STAFF REPORT

SUBJECT: H-2021-0006
Sadie Creek Drive-Through – CUP

LOCATION: South of E. Ustick Rd. on the west side of N. Eagle Rd., in the NE ¼ of Section 5, Township 3N., Range 1E.

Conditional use permit for a drive-through establishment within 300-feet of another drive-through establishment on 1.18-acres of land in the C-G zoning district.

A. Proposed Site Plan (dated: 1/27/2021)

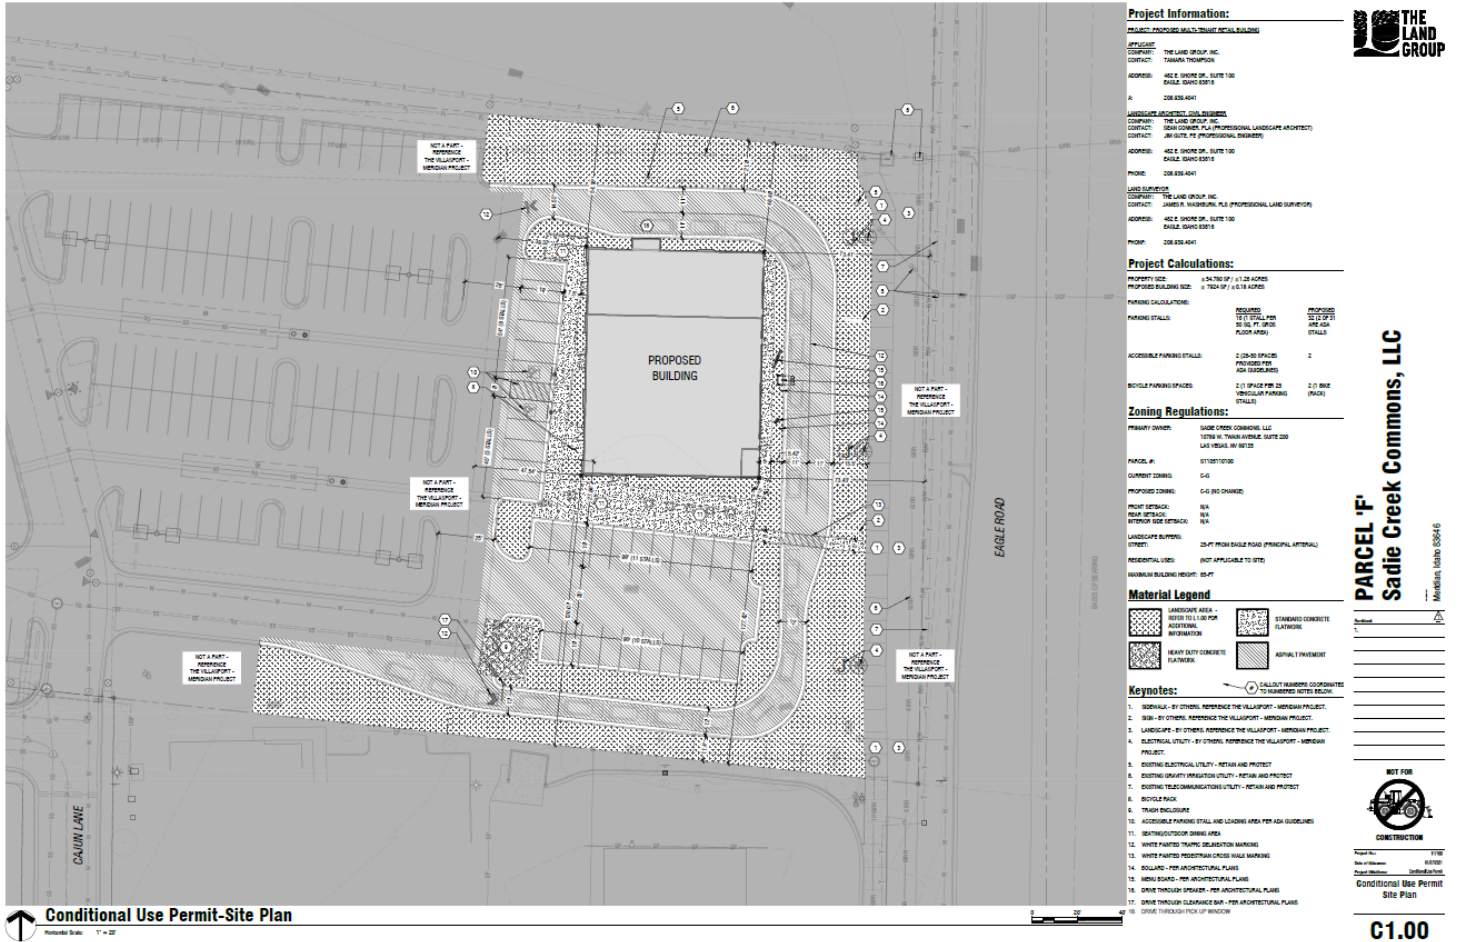
At over 400’ from the drive-through window to the nearest drive-aisle that provides access to the parking area, the stacking lane should have sufficient capacity to serve the use without obstructing driveways and drive aisles by patrons. The stacking lane will hold approximately 21 vehicles.

The stacking lane is a separate lane from the circulation lanes needed for access and parking.

The stacking lane is not located within 10’ of any residential district or residence.

The stacking lane exceeds 100’ in length and an escape lane is proposed.

The drive-through is visible from N. Eagle Rd./SH-55, a public street along the east boundary of

the site, for surveillance purposes.

Access: Access is provided to this site from the west via N. Cajun Ln. and E. Picard Ln., both private streets, across the Villasport property to the west and via E. Ustick Rd., an arterial street, from the north. **A cross-access/ingress-egress easement is needed across the adjacent properties to the west and north (Parcels #S1105110111 and S1105110030) for access to this site. A copy of the recorded easements should be submitted with the Certificate of Zoning Compliance application for this project. Both access driveways should be constructed with development of this site along with all of the frontage improvements along E. Ustick Rd. and N. Eagle Rd./SH-55 in accord with the Development Agreement. All off-site driveways and site improvements should be depicted on the plans.**

A pedestrian walkway is depicted on the site plan from the perimeter sidewalk along N. Eagle Rd. to the main building entrance as required by UDC 11-3A-19B.4a. **Where pedestrian walkways cross vehicular driving surfaces, the walkways are required to be distinguished from the vehicular driving surfaces through the use of pavers, colored or scored concrete, or bricks as set forth in UDC 11-3A-19B.4. The site plan submitted with the Certificate of Zoning Compliance application should reflect compliance with this standard.**

Landscaping: Parking lot landscaping is required to be provided in accord with the standards listed in UDC 11-3B-8C. Landscaping is depicted on the landscape plan in Section VII.B in planter islands within the parking area as required. **A minimum 5-foot wide perimeter landscape buffer is required to be provided adjacent to parking, loading or other paved vehicular use areas as set**

forth in UDC 11-3B-8C.1; landscaping should be provided adjacent to the drive-through lane along the north boundary of the site in accord with this requirement. The easement for the relocated Milk Lateral should be depicted on the plan to ensure no trees are placed within the easement.

The landscape plan depicts the pathway and improvements east of the pathway along N. Eagle Rd./SH-55 as “not a part” to be constructed with the Villasport project. The Development Agreement requires all of the frontage improvements (i.e. street buffers, sidewalks, pedestrian lighting, etc.) on this site and the Villasport site to the west along N. Eagle Rd./SH-55 and E. Ustick Rd. to be installed with the first phase of development. **It was anticipated that Villasport would be the first phase of development; however, if this project ends up being the first phase, it’s responsible for these improvements, including those off-site – the plans should be revised to include these improvements.**

Because the drive-through lane and back of the building (with mechanical equipment) will be highly visible from N. Eagle Rd./SH-55, Staff recommends additional landscaping (i.e. coniferous trees/bushes) is provided within the street buffer to screen this area and these functions while preserving a clear view of the drive-thru window for surveillance purposes.

2. The site plan and landscape plan submitted with the Certificate of Zoning Compliance application shall be revised as follows:
 - a. The stacking lane, menu and speaker location(s), and window location shall be depicted in accord with UDC [11-4-3-11B](#).

- b. Where pedestrian walkways cross vehicular driving surfaces, the walkways shall be distinguished from the vehicular driving surfaces through the use of pavers, colored or scored concrete, or bricks as set forth in UDC [11-3A-19B.4](#).

- d. Include additional landscaping (i.e. coniferous trees/bushes) within the street buffer along N. Eagle Rd./SH-55 to screen the back side of the building and mechanical equipment while preserving a clear view of the drive-thru window for surveillance purposes.

- e. Depict off-site improvements required by the Development Agreement, including a 35-foot wide street buffer along N. Eagle Rd./SH-55, an entryway corridor, and a 25-foot wide street buffer is required along E. Ustick Rd., landscaped per the standards listed in UDC [11-3B-7C](#) per UDC Table 11-2B-3. A 10-foot wide multi-use pathway is required within a public use easement and pedestrian lighting and landscaping is required to be provided within the street buffer along N. Eagle Rd./SH-55 in accordance with the standards listed in UDC [11-3H-4C.3](#) and [11-3B-12C](#).

- f. A minimum 5-foot wide perimeter landscape buffer is required to be provided adjacent to parking, loading or other paved vehicular use areas as set forth in UDC 11-3B-8C.1; landscaping shall be provided adjacent to the drive-through lane along the north boundary of the site in accord with this requirement.

- g. Graphically depict the easement for the Milk Lateral along the north and east boundaries of the site; no trees should be placed within the easement.

- h. Depict both access driveways to this site via E. Ustick Rd. and E. Picard Ln./N. Cajun Ln.
3. Direct access via N. Eagle Rd./SH-55 is prohibited.
4. A recorded cross-access/ingress-egress easement shall be obtained across the adjacent properties to the west and north (Parcel #S1105110111 and #S1105110030) for access to this site; a copy of the easements shall be submitted to the Planning Division with the Certificate of Zoning Compliance application.

BUILDING ELEVATIONS

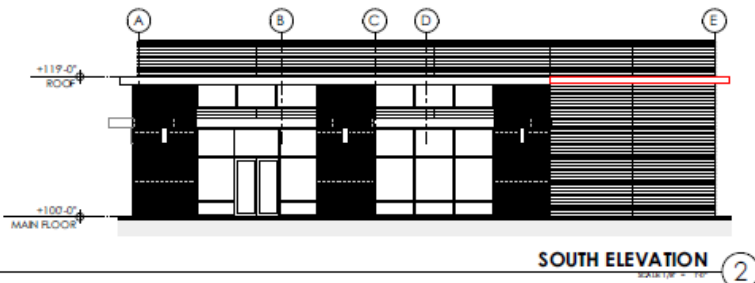
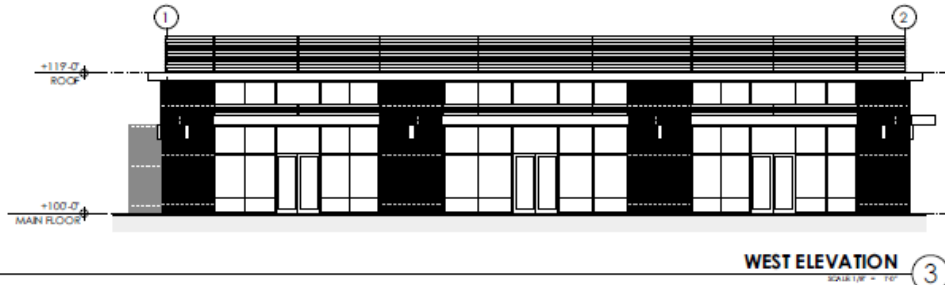
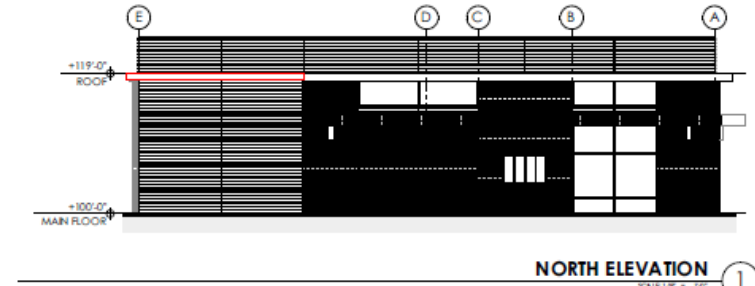
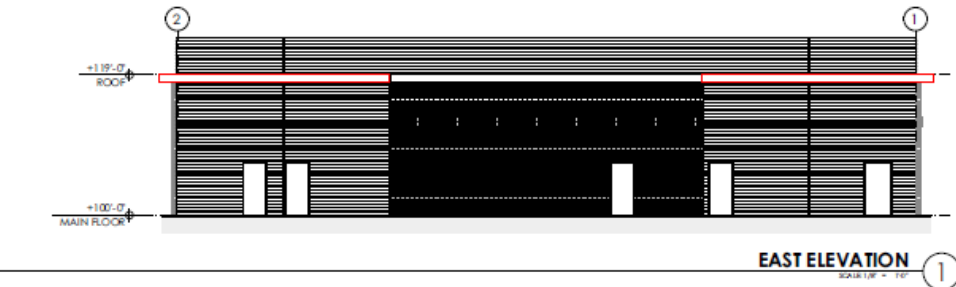
Mechanical Equipment: All mechanical equipment on the back of the building and outdoor service and equipment should be incorporated into the overall design of buildings and landscaping so that the visual and acoustic impacts of these functions are fully contained and out of view from adjacent properties and public streets as set forth in UDC [11-3A-12](#).

Building Elevations: Conceptual building elevations were submitted as shown in Section VII.C that incorporate a mix of materials consisting of PAC clad formed metal wall panels in slate gray with metal flashing and trim in light gray, a mix of white and onyx colored brick and with a glass store-front and a flat roof. **These elevations are *not* approved; final design shall be consistent with the design standards listed in the [Architectural Standards Manual](#).**

The trash enclosure should be constructed with similar materials and colors to match the building.

- c. All mechanical equipment on the back of the building and outdoor service and equipment areas should be incorporated into the overall design of buildings and landscaping so that the visual and acoustic impacts of these functions are fully contained and out of view from adjacent properties and public streets as set forth in UDC [11-3A-12](#).

9. Parking for the overall site shall be provided in accord with the standards listed in UDC 11-4-3-49 for restaurants.
10. A Certificate of Zoning Compliance and Design Review application shall be submitted and approved for the proposed use prior to submittal of a building permit application. The design of the site and structure shall comply with the standards listed in UDC 11-3A-19 and the design standards listed in the Architectural Standards Manual.
